## Product Change Notification

### POWER TVS DIODES

## Bourns® Power TVS Diode Product Labels will Include Certified Safety Symbols

#### New Label with UL symbol

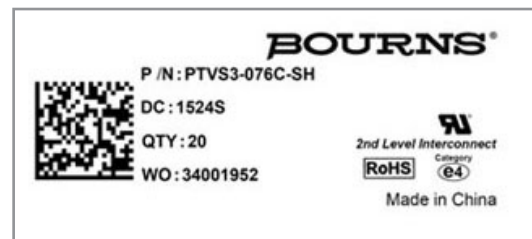
In the spirit of continuous improvement, production labels for Bourns® Power TVS Diodes will include certified safety symbol(s) (e.g., UL, etc.) on the 2D barcodes. The current 2D barcode format includes the part number, quantity, date or lot code, and work order information. The new label, with the certified safety symbols, will provide safety information.
